UNITED STATES PATENT AND TRADEMARK OFFICE

Office Action Summary

09/911,563

DETAILED ACTION

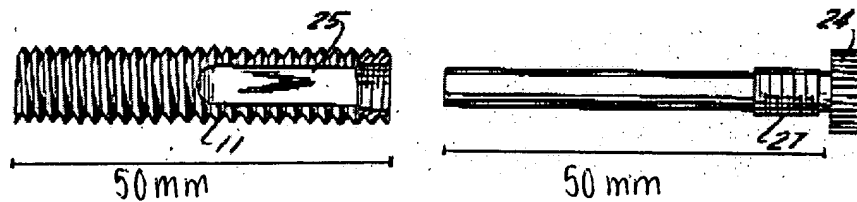
Claims 1-12 are rejected under 35 U.S.C. 102(b) as being anticipated by Zeman (US 3,540,451 A).

Zeman discloses a drainage cannula with threaded sealing pin comprising an access port defining an elongated tubular body (11) of predetermined length with a central lumen (25) having opposed proximal and distal end portions (the proximal end is interpreted as the portion adjacent to overprotective button (22), while the distal end is labeled (11a)) and an inner diameter, the distal end portion defining a flat annular distal end surface (see Figure 1 or 2); and an elongated cylindrical plug (24) dimensioned and configured for insertion into the central lumen of the cannula and ready removal therefrom, the plug body having a length that is substantially equal to the cannula, a flat circular distal end surface, see Figure 2, and an outer diameter that is substantially equal to the inner diameter of the lumen so as to prevent flow between the outer diameter of the plug and the inner diameter of the lumen of the cannula when the plug is engaged therein and the flat annular distal end surface of the access port is coplanar with the flat circular distal end surface of the plug body (see Figures 1 & 2); and a locking mechanism (27) associated with the proximal end of the elongated cylindrical plug body adjacent

a handle portion (24) thereof for releasably coupling the plug body to the cannula, see Column 4, lines 8-10; Column 4, lines 26-28, and Figures 1 & 2.

** Note that the Figures do not show the sealing pin/plug inserted into the cannula/port, however the Examiner measured the lengths of the pin/plug and the cannula/port, as depicted in Figure 2, and discovered that the lengths are equal and thus upon insertion would yield a coplanar surface, see below for details.
